Subject: Field Repair Notice R2202 Engine Software and Label Retrofit - Engine Model Year 2023 567, 579, and 520 Chassis
EXPIRATION DATE: 12/31/2022

R2202: PACCAR MX Engine Model Year 2023 Pre-Production Retrofit

R2202: PACCAR MX Engine Model Year 2023 Pre-Production Retrofit

Engine Emissions label placement:

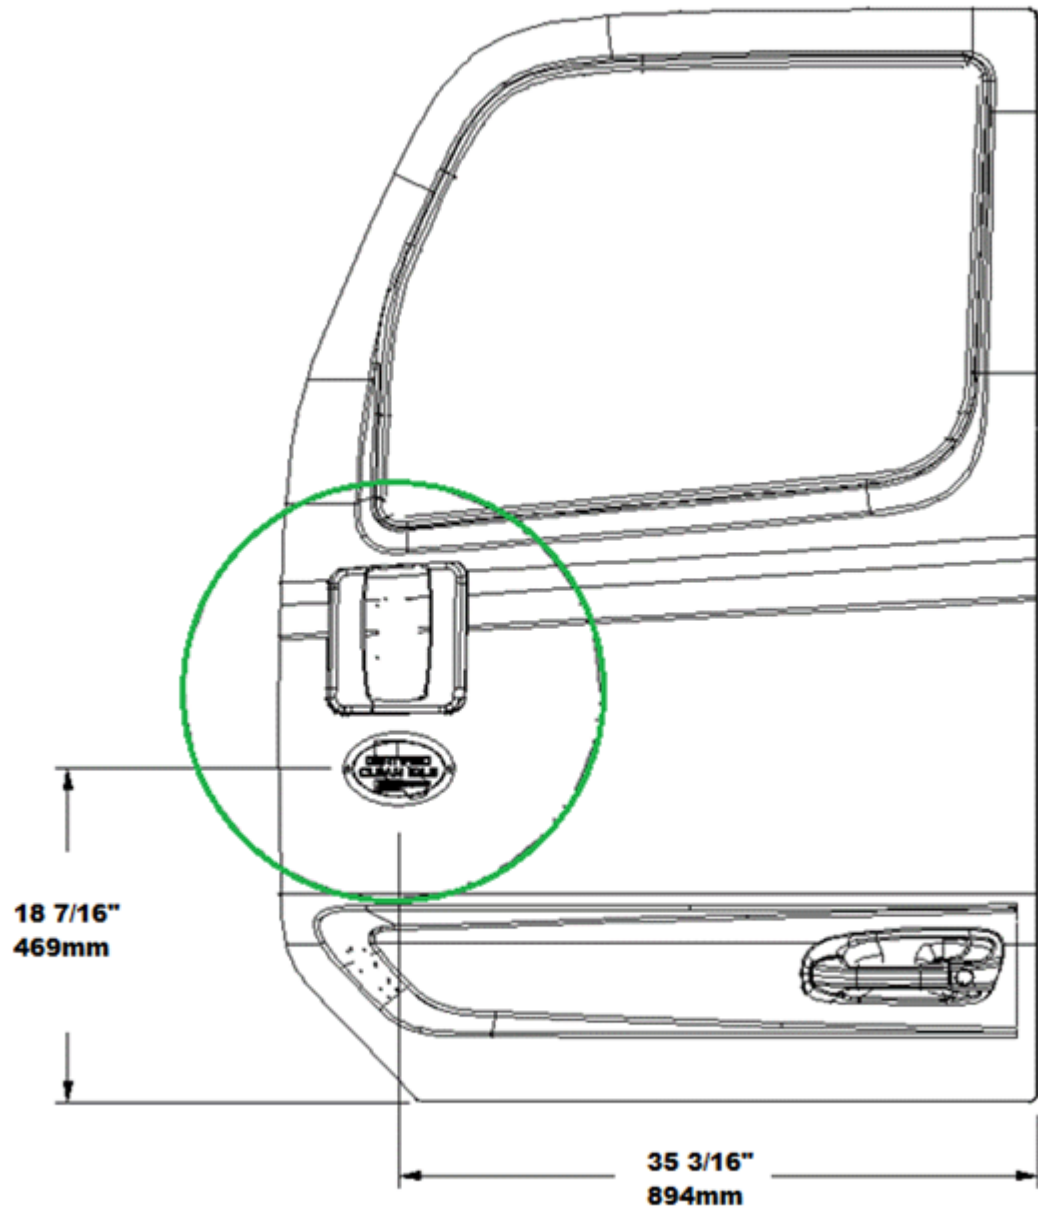
12. Apply the Engine Emissions Information label to the engine air horn and the Clean Idle label to the driver's door of the vehicle as shown below.

Engine Emissions label placement:

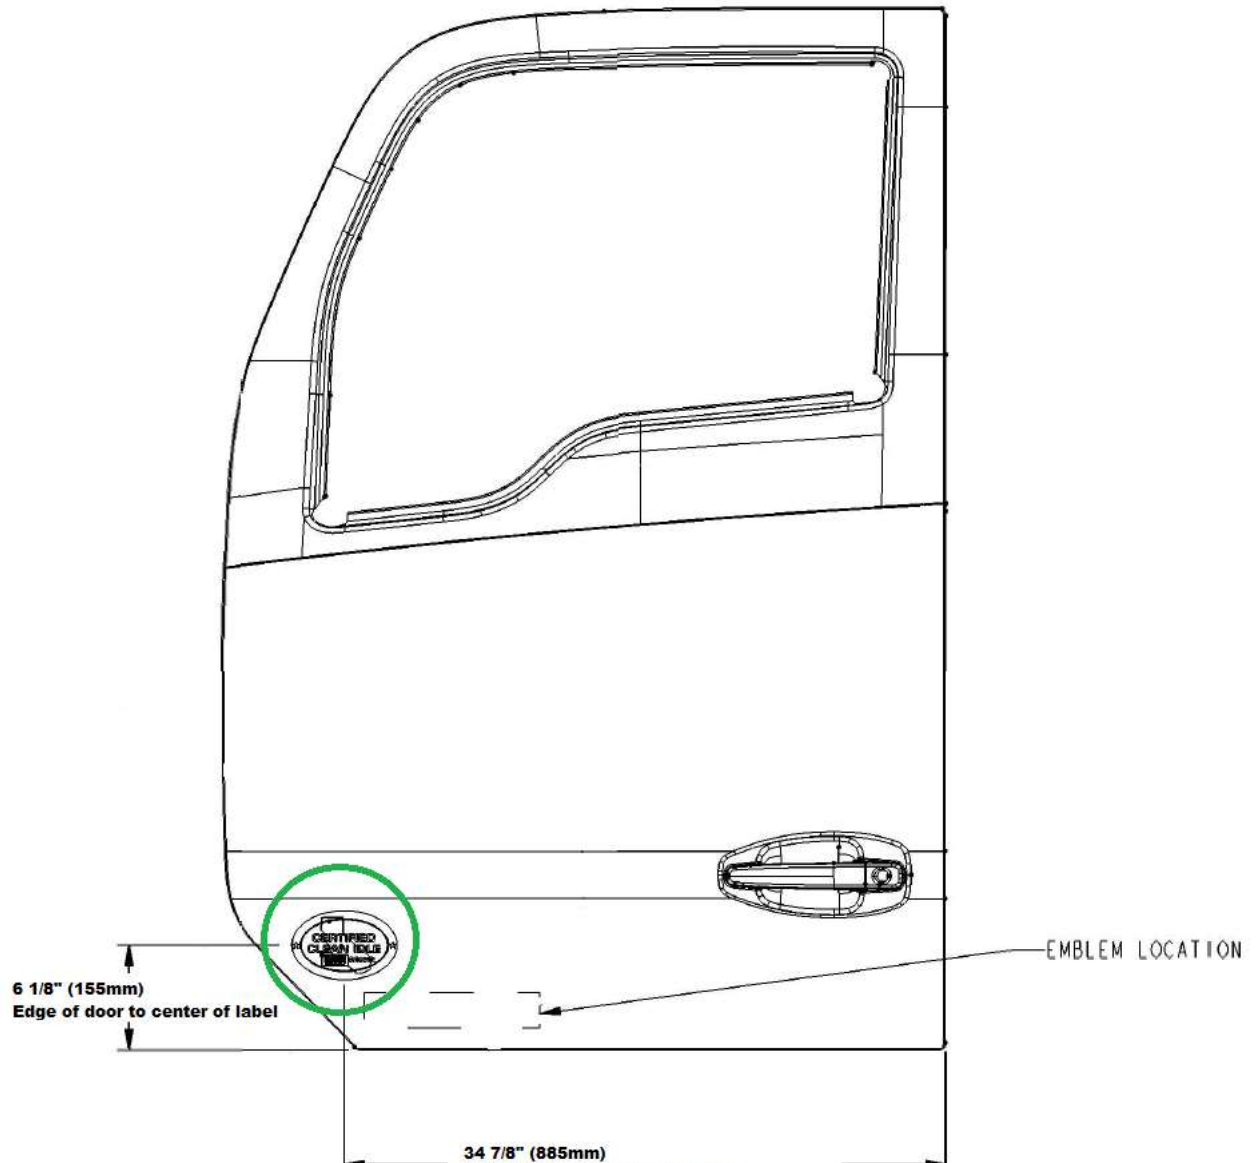
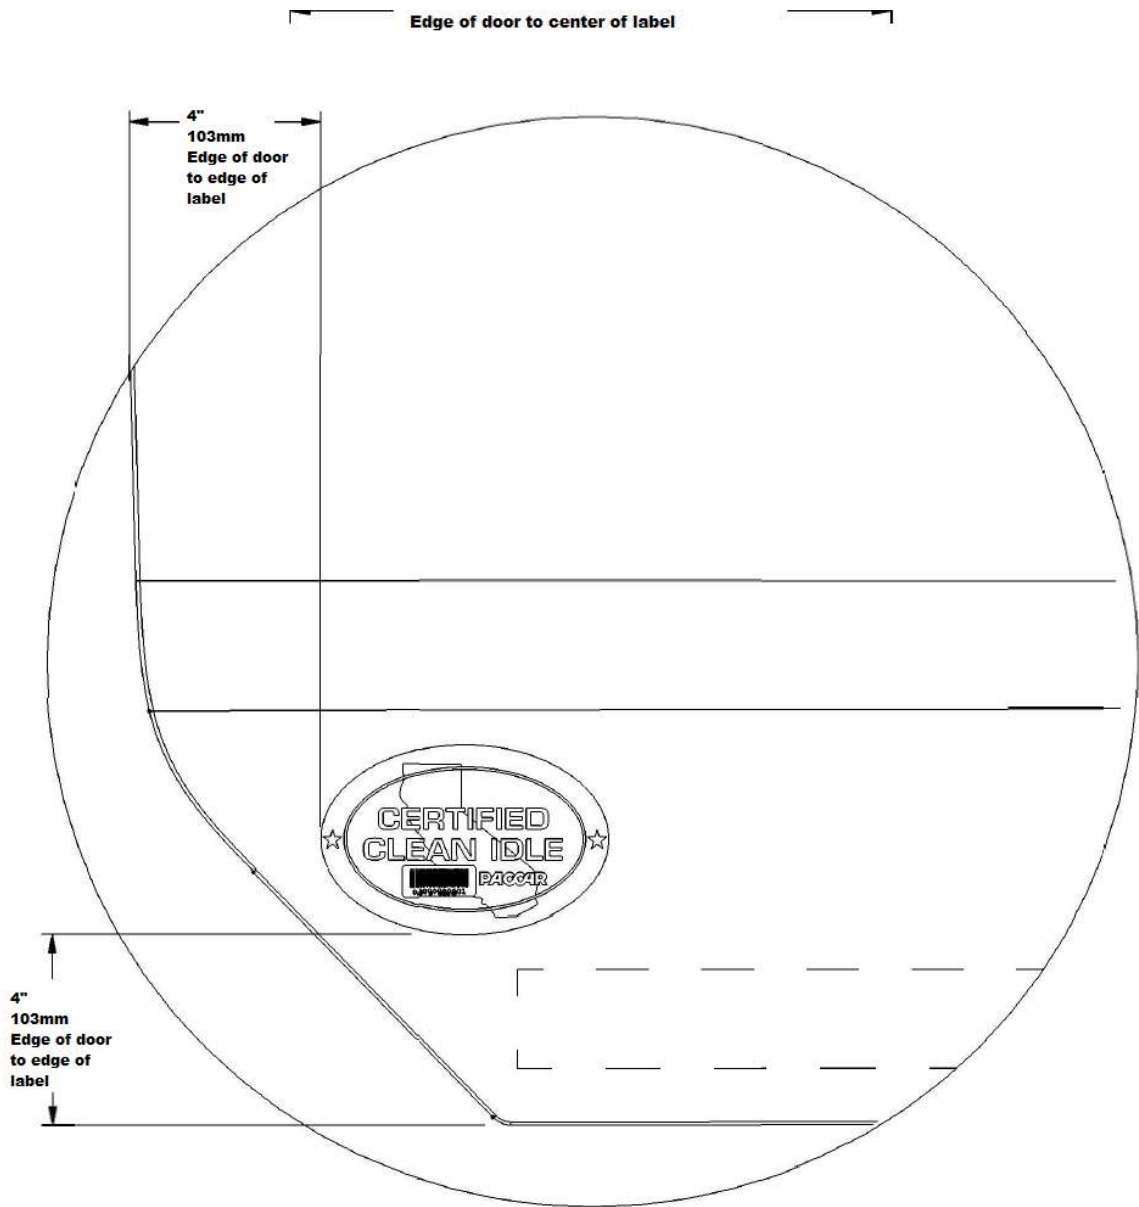
12. Apply the Engine Emissions Information label to the engine air horn and the Clean Idle label to the driver's door of the vehicle as shown below.
